ADDENDUM NO. 3

November 11, 2022

LIBERTY ELEMENTARY SCHOOL RENOVATIONS Chesterton, IN 46304

**CASEWORK SCHEDULE AND
ELEVATIONS**

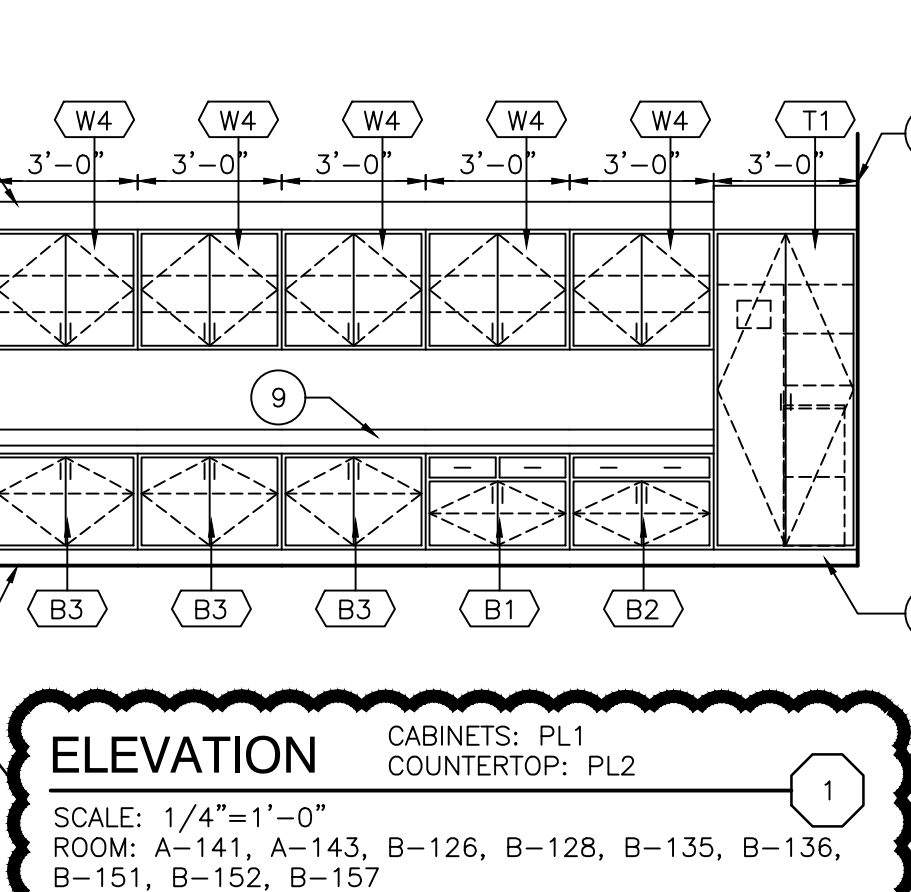
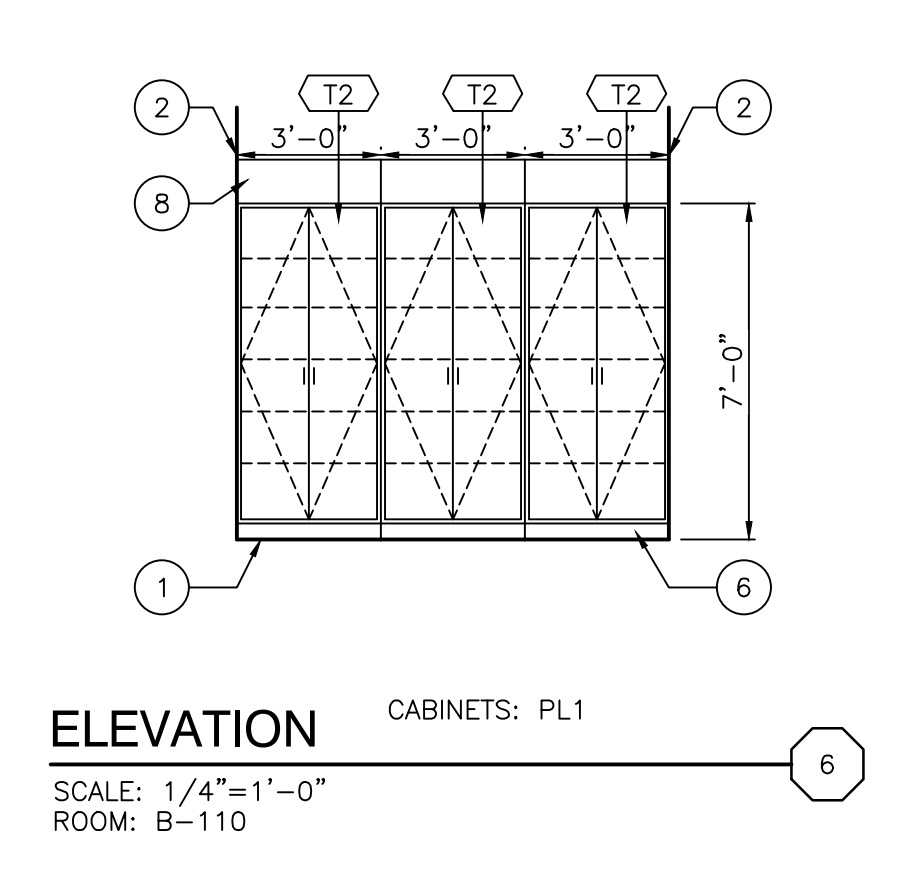
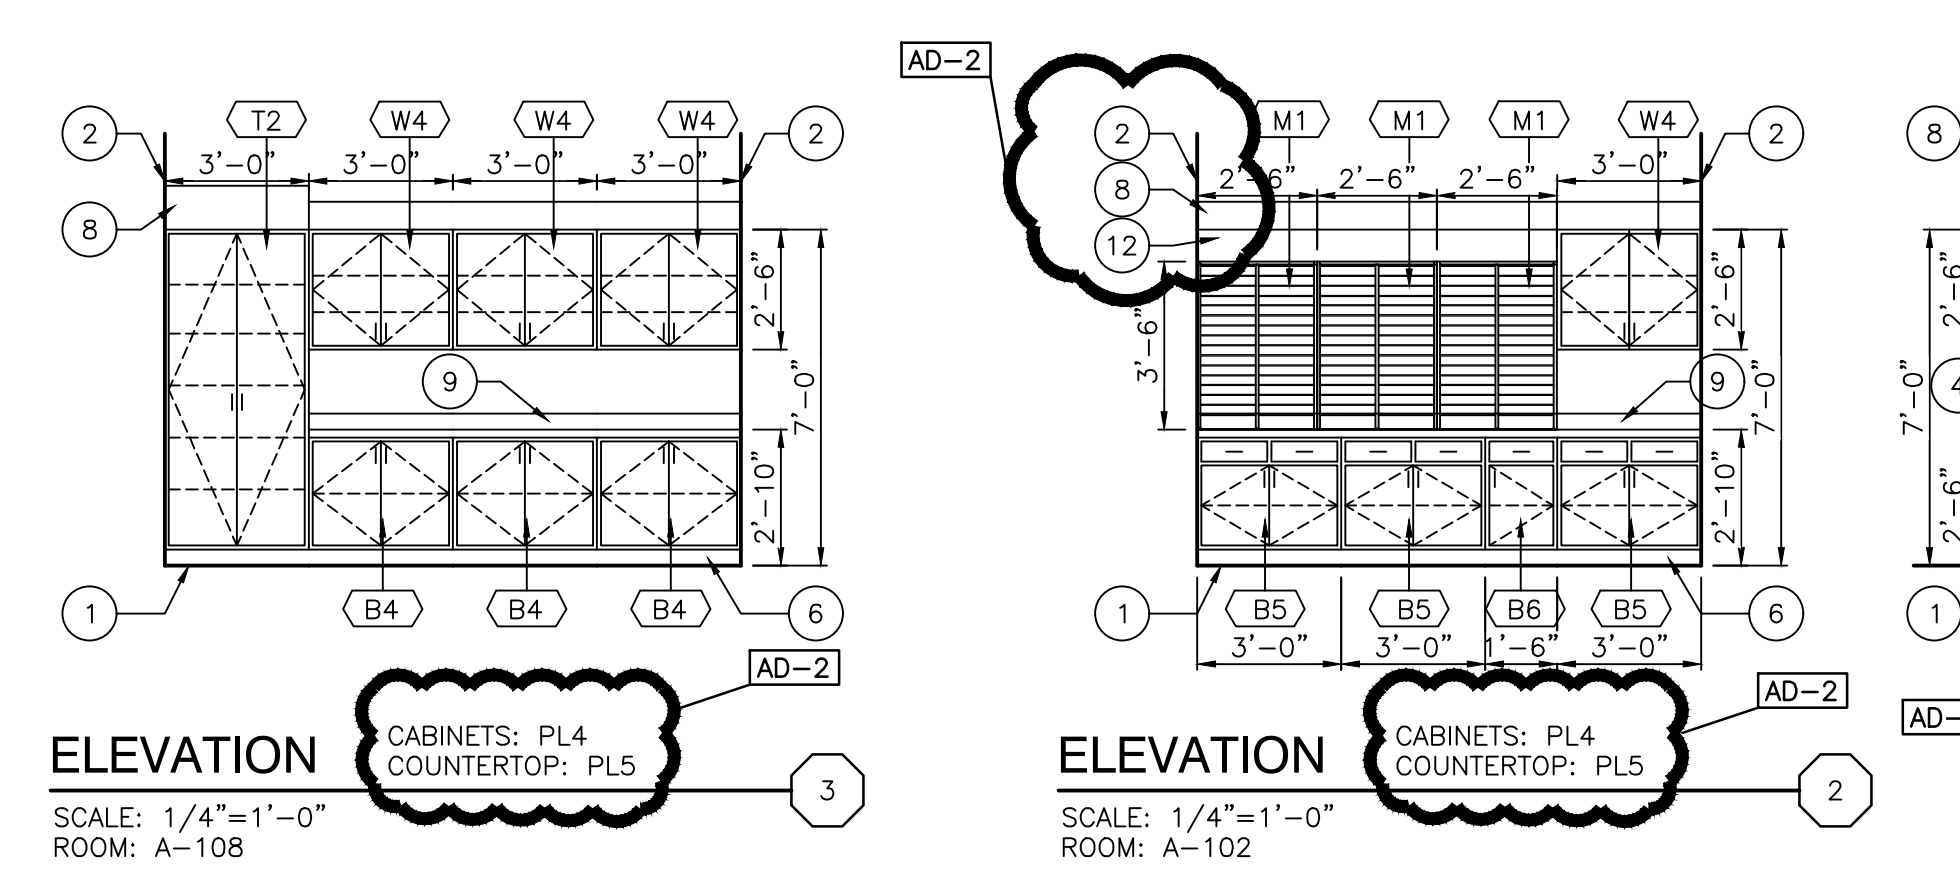
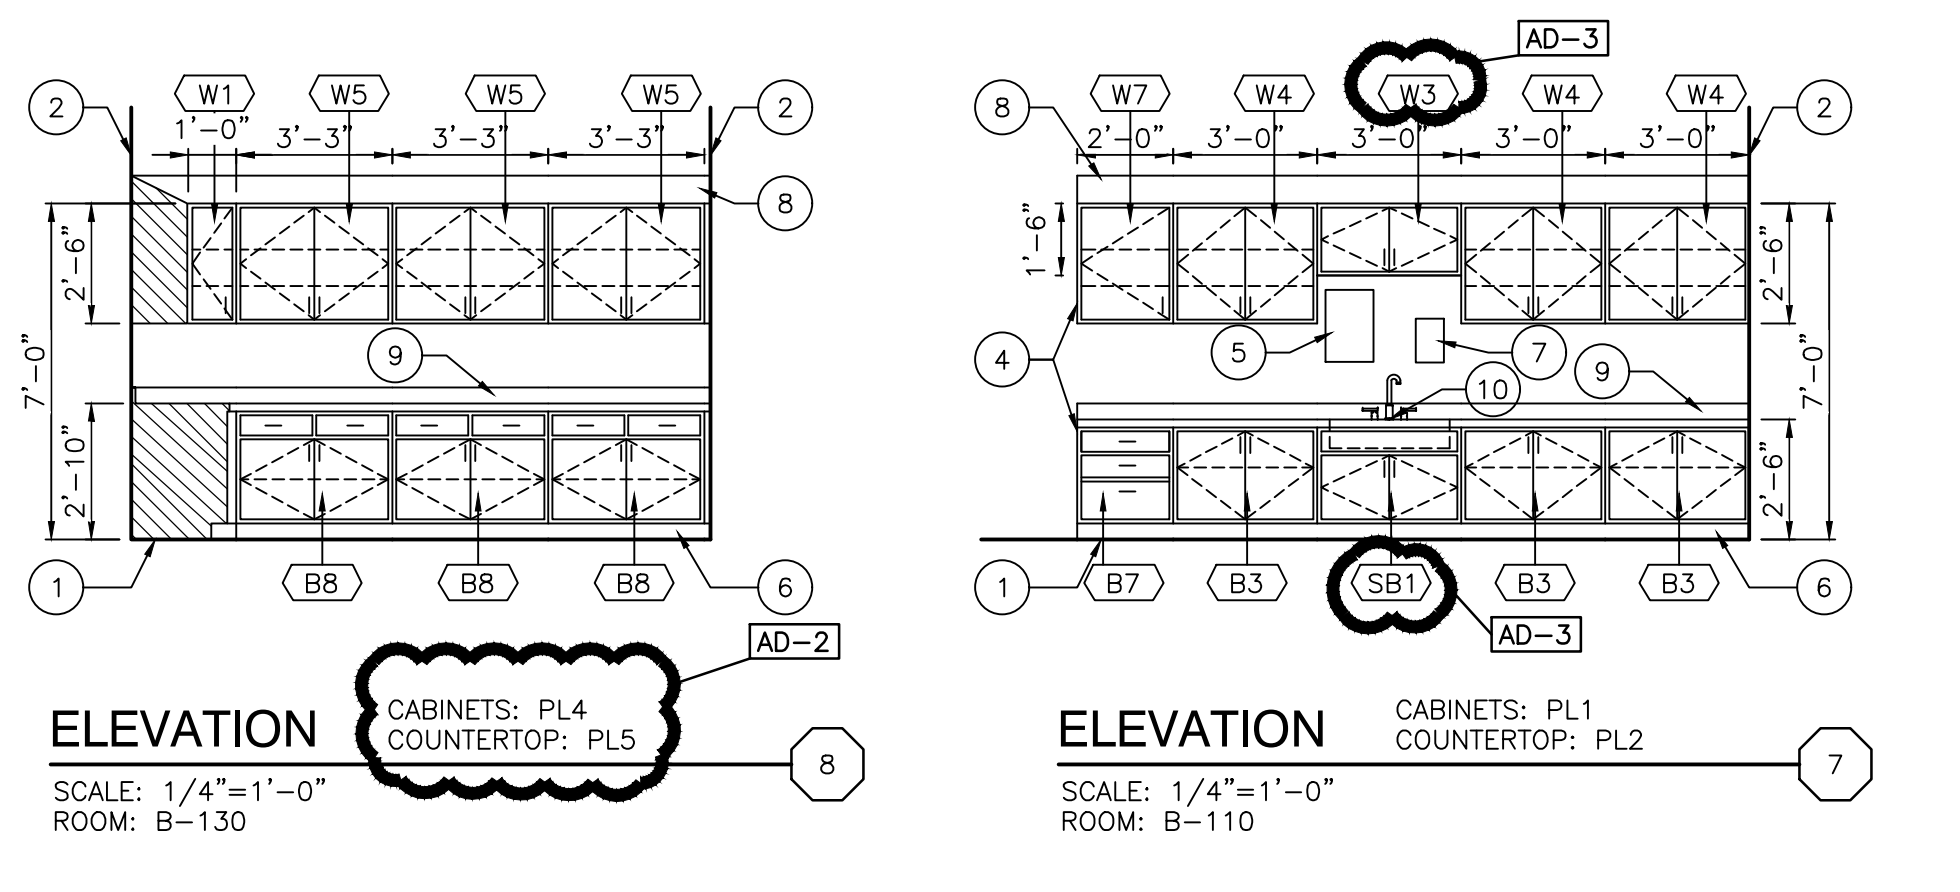
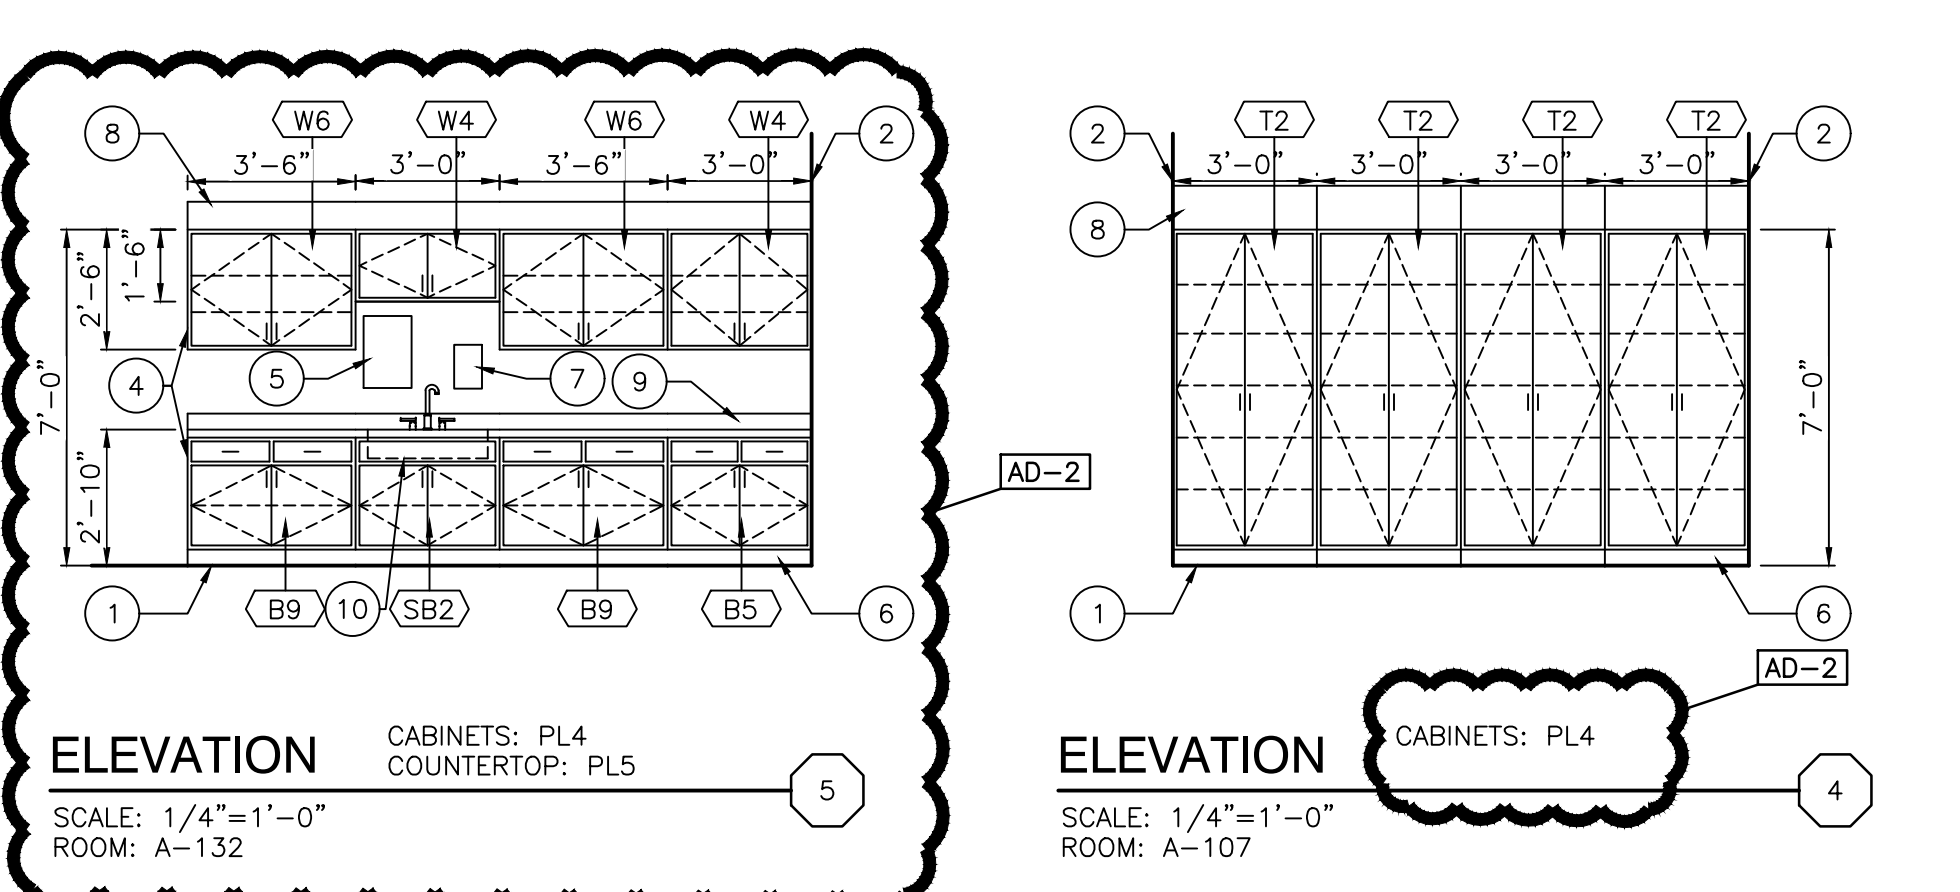
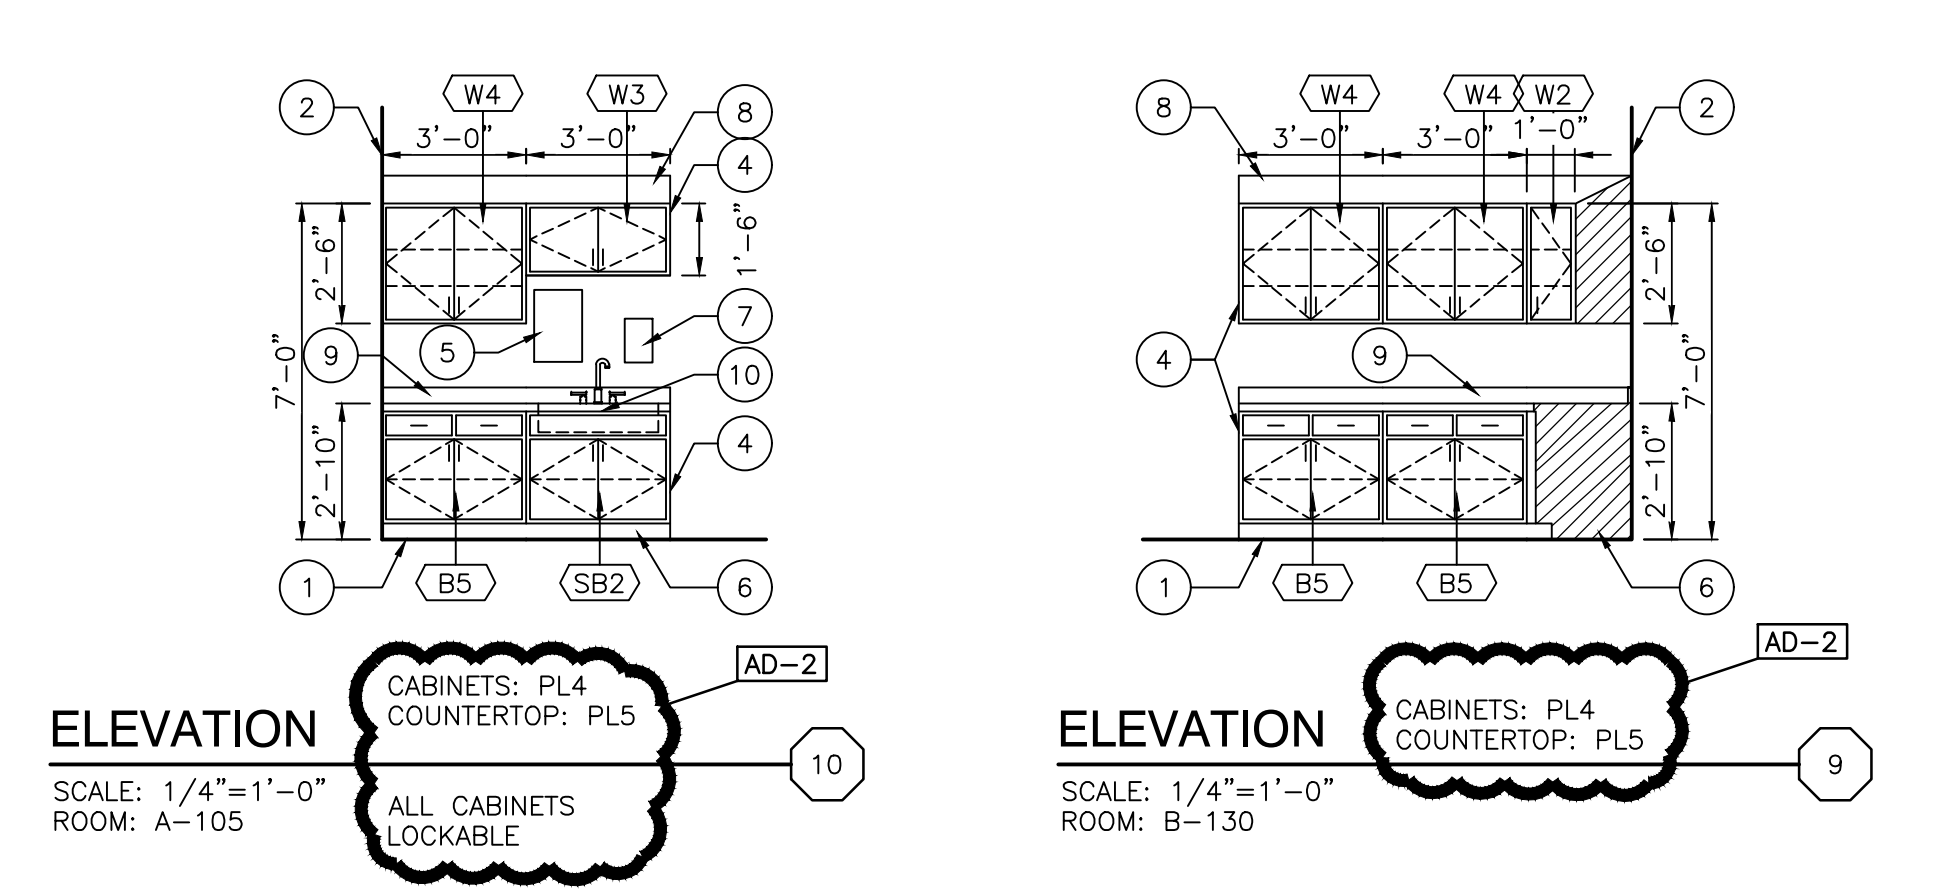
- A. Refer to revised full size drawings, included in this Addendum, for the following revisions:
1. Casework elevation cabinet model adjustment.

TYPICAL RESTROOM TILE PATTERN
SCALE: 1/4" = 1'-0"

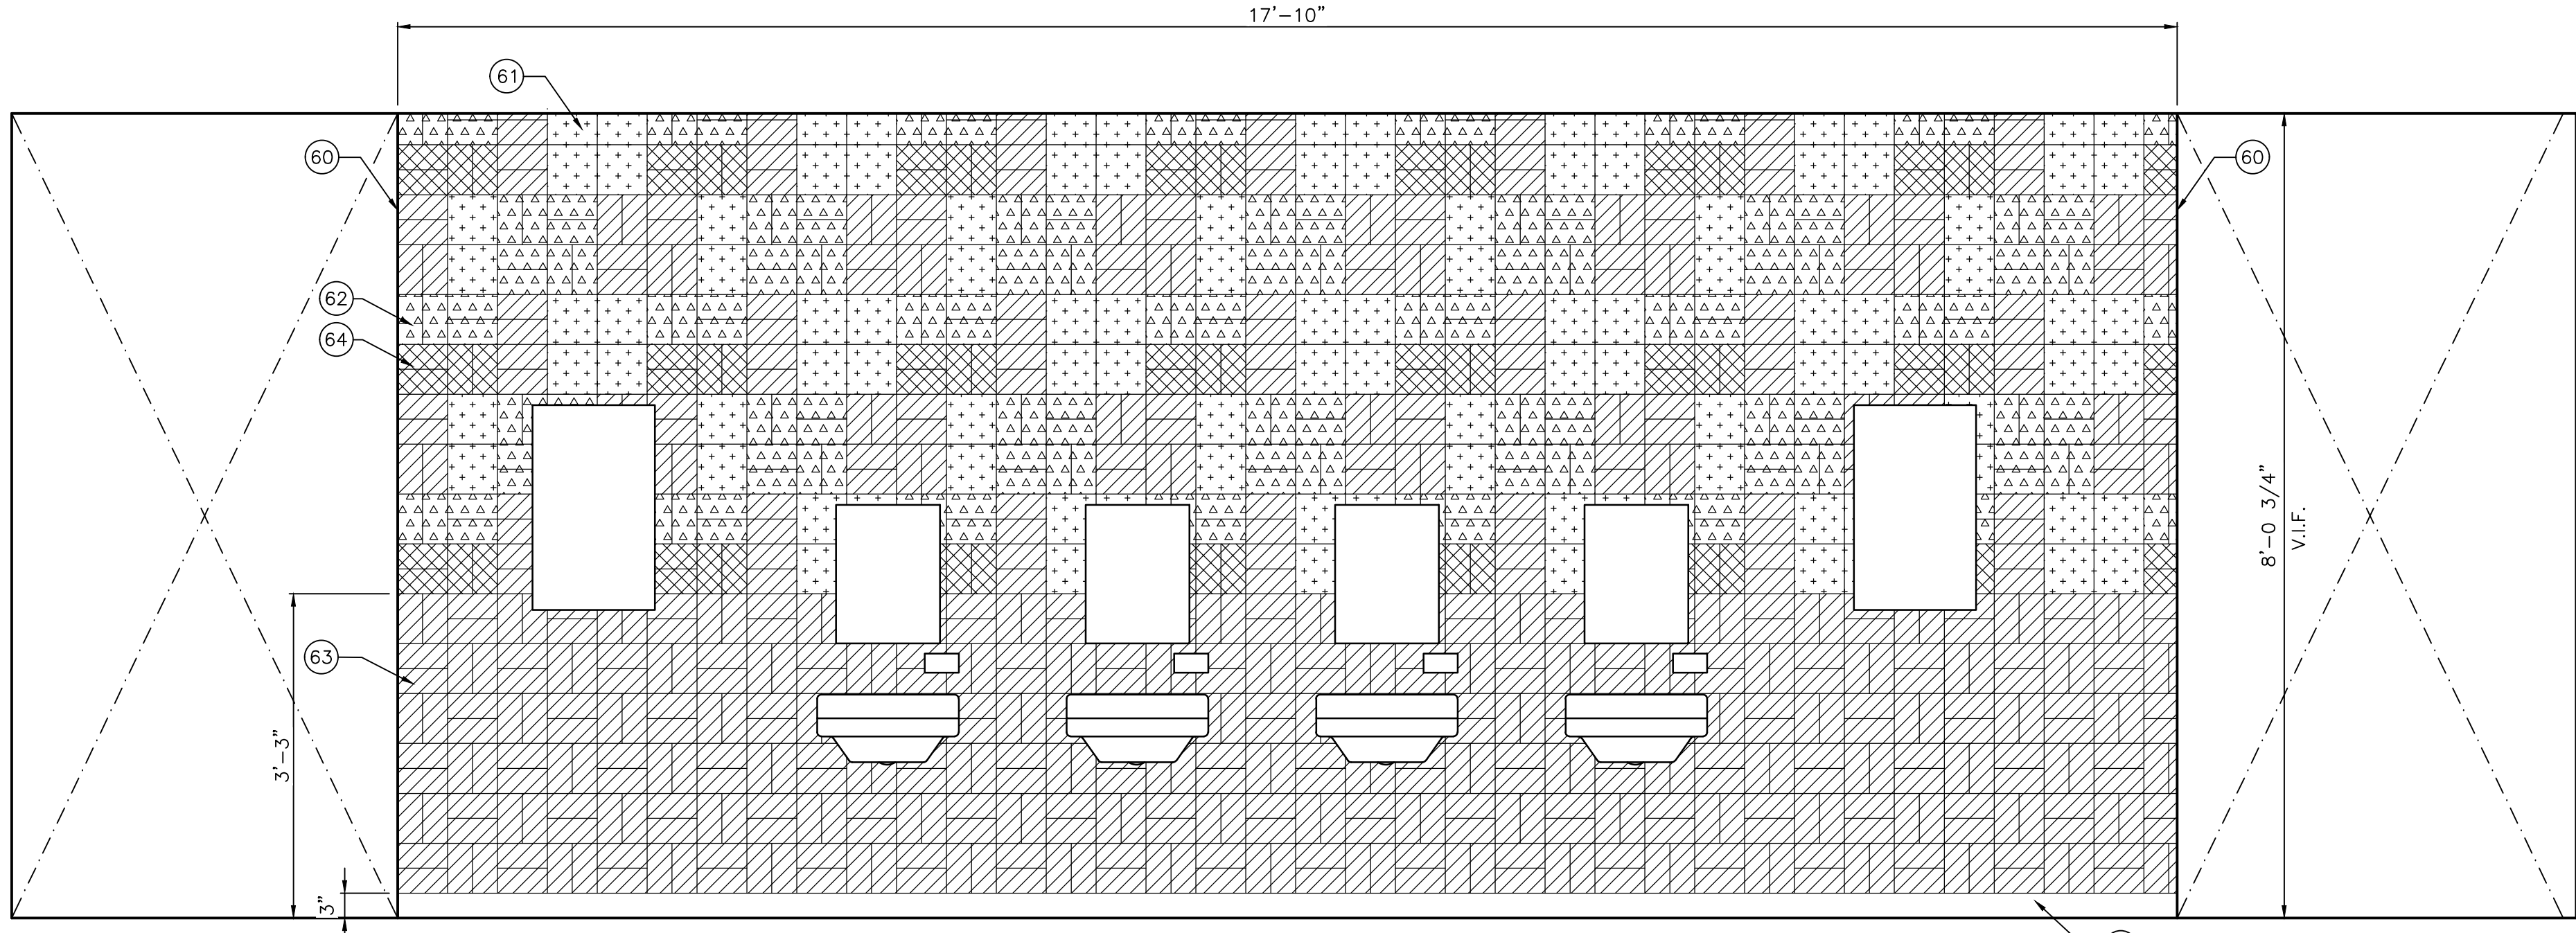
- A. Refer to revised full size drawings, included in this Addendum, for the following revisions:
1. Note addition of wall tile pattern elevations.
